ADDENDUM A

June 14, 2019

JOINT FORCE HEADQUARTERS PAVER RENOVATION
SCO#: 18-18397-01A

4 NEW ENCLOSURE SECTION DETAIL
A5-01 1 1/2" = 1'-0"

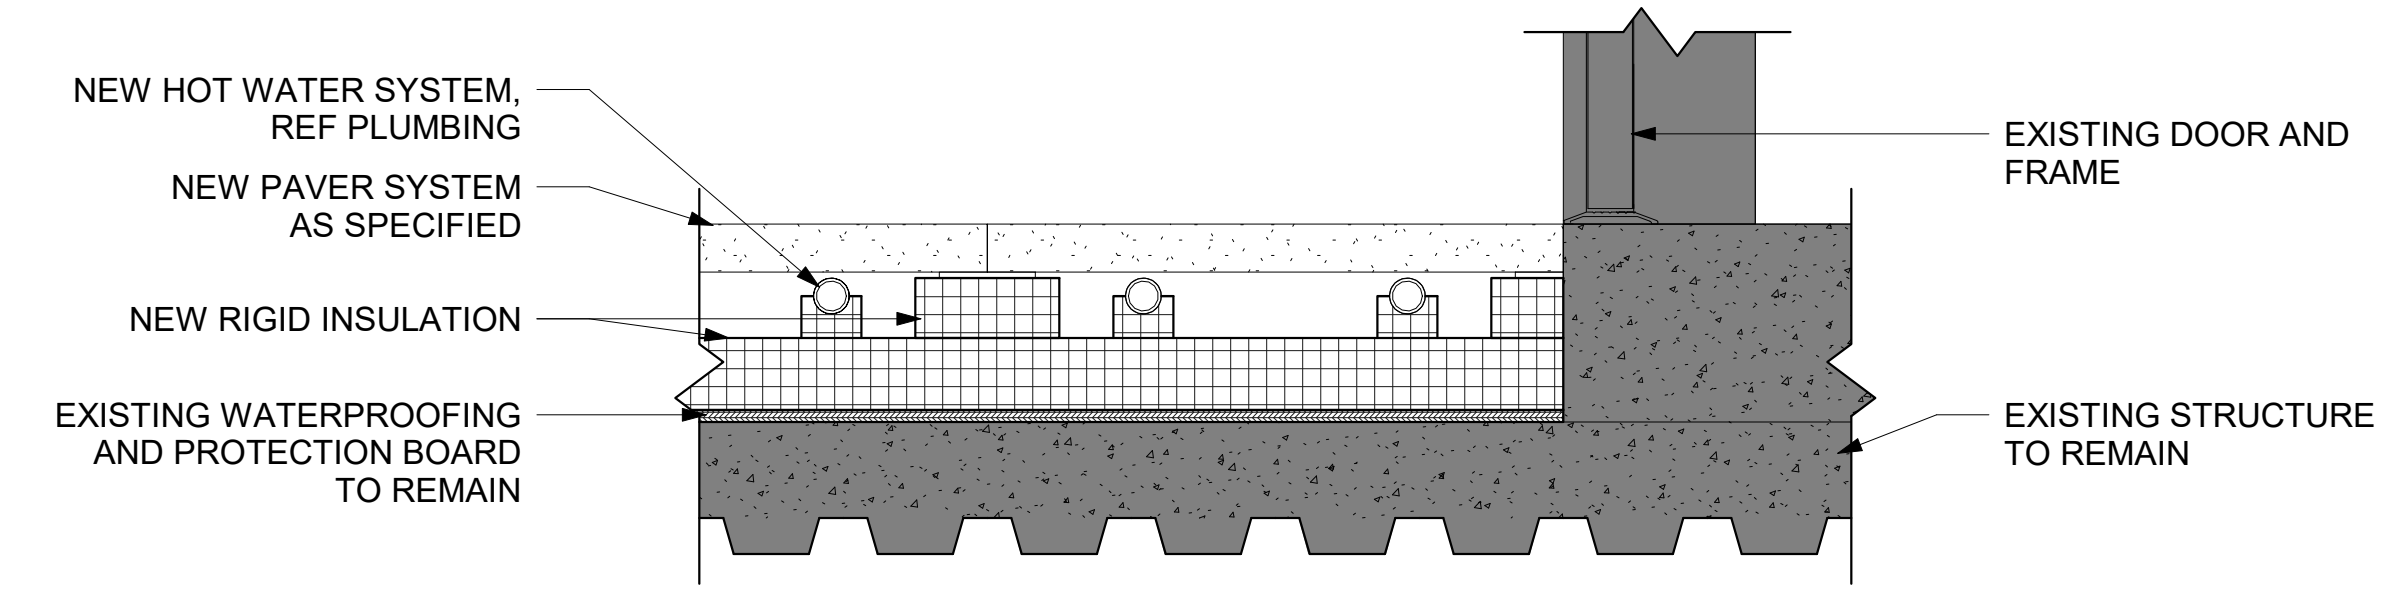
1. **REVISION:** Sheet A5-01: Drawing 4/A5-01 NEW ENCLOSURE SECTION DETAIL, Revised to show section cut referencing 7/A5-01.
